**State Significant Development Application (SSD-10352-Mod-1)
Moriah College, 101 York Road and 1-3 Queens Park Road, QUEENS PARK NSW 2022
(Waverley Council Ref.: SSD-1/2025)**

This submission seeks to convey Council's review of and comment on the application.

Figure 1 – Extract of the Map in Waverley LGA Flood Study, showing the Waverley Flood Risk Precincts with annotations of indicative location of new proposed kerb inlet pits and pipelines

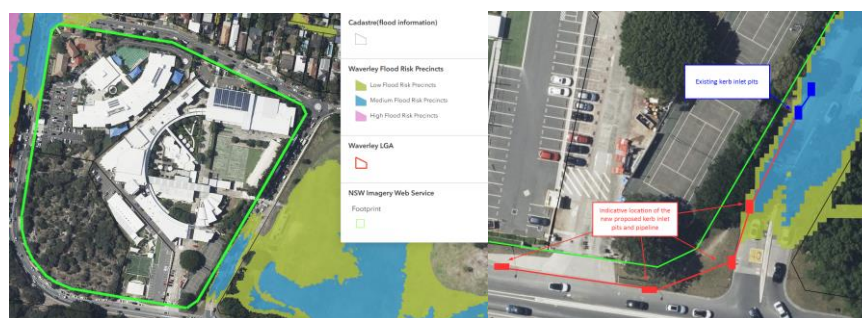
- ii. The approved SSD includes a direct stormwater connection to the kerb inlet pit on Baronga Avenue from the development site. However, this modification proposes a larger scope of work by extending the drainage network (including the construction of four new kerb inlet pits) from York Road, and a connection at the existing kerb inlet pit on Baronga Avenue.

- iv. Baronga Avenue to the east of the site (where the stormwater discharge point is proposed) is identified as flood affected under the Council endorsed Waverley LGA Flood Study 2021 (as shown in **Figure 1** below). No flood planning controls are applicable to the development, however, hydraulic calculations for the OSD tank outlet with appropriate tailwater conditions shall be submitted to Council for approval prior to the issue of the relevant construction certificate to show adequate capacity for the connection into the Council pipe network downstream. A condition to this effect is recommended to be added to any SSD consent.

Given the significant changes to the works, approval must be sought from Council for the work on Council's assets. Hence, a condition of consent to this effect is recommended to be added to the SSD consent. This will allow Council to request the pre-construction and post construction CCTV to confirm the condition of the Council's stormwater pipes and pits servicing the site and to ensure the stormwater infrastructure was adequately protected and there is no damage due to the construction activities or the connection to the private property connection.
